RSRTG/RSTTG and RTD allowances

IEEE S802.16j-08/112r1

IEEE 80216-08/020; IEEE 802.16 Letter Ballot Recirc #28c, on P802.16j/D4

8.4.4.2 PMP frame structure

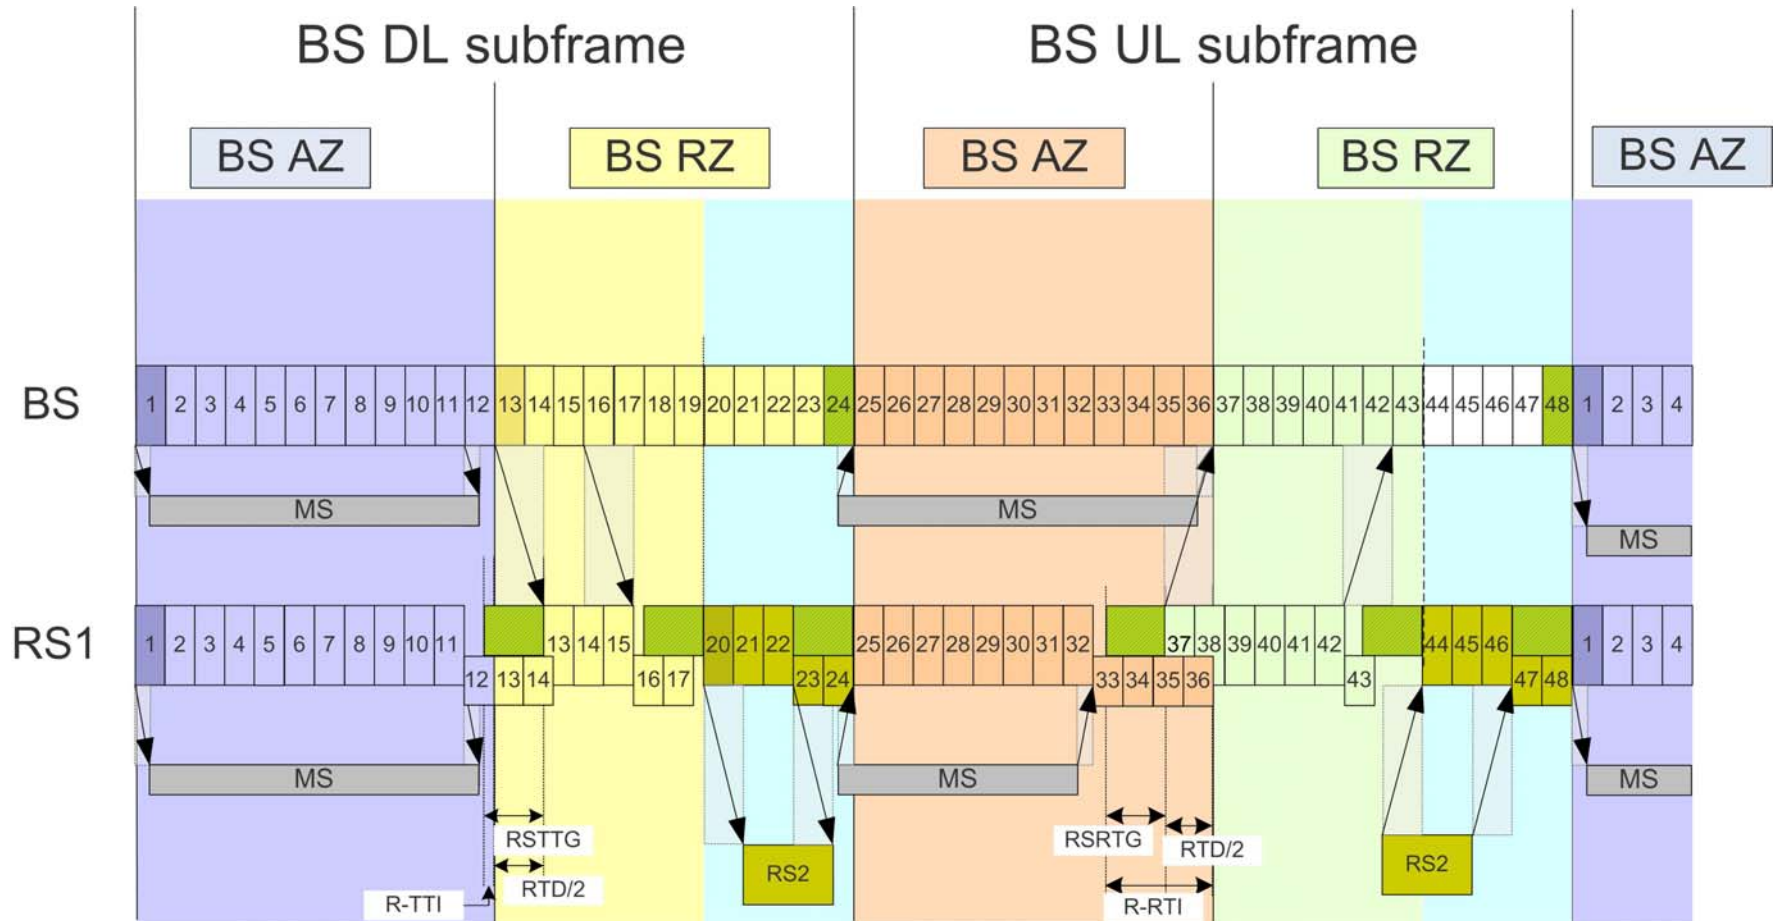
An R-RTI that allows for the RSRTG shall be inserted between the zones where RS is required to switch from receive to transmit mode. An RS shall not be required to transmit or receive during the symbols in R-RTI

An R-TTI shall be inserted between the zones where RS is required to switch from transmit to receive mode. An RS shall not be required to transmit or receive during the symbols in R-TTI.

- R-RTI/TTI is not inserted between zones. Zones are defined from perspective of MR-BS. R-RTI/TTI are relevant to an RS transmit and receive windows.
- During R-RTI in UL, transmission takes place so its not correct to say that RS shall not be required to transmit during the symbols in R-RTI
- During R-RTI in DL, reception takes place so its not correct to say that RS shall not be required to receive during the symbols in R-RTI

- **Simplify current description**
- **Remove R-RTI and R-TTI**
- **Proposed text**
 - All DL transmissions shall be symbol aligned with the corresponding symbols at the MR-BS.

- All DL receive times shall be determined according to the time delay from the corresponding symbols at the MR-BS, and shall be based on the RTD between the transmitting and receiving station.

- All UL receive times shall be symbol aligned with the corresponding symbols at the MR-BS.
 - All UL transmissions shall be time advanced according to the RTD between the transmitting and receiving stations, such that they are symbol aligned at the receiving station with the corresponding symbols at the MR-BS.

- An RS shall begin a switch from receive to transmit mode at least RSRTG before the beginning of the first transmit time. The RS shall not be required to transmit or receive during the symbols that overlap the receive-to-transmit switching time interval.

- An RS shall begin a switch from transmit to receive mode at least RSTTG before the beginning of the first receive time. The RS shall not be required to transmit or receive during the symbols that overlap the transmit-to-receive switching time interval.
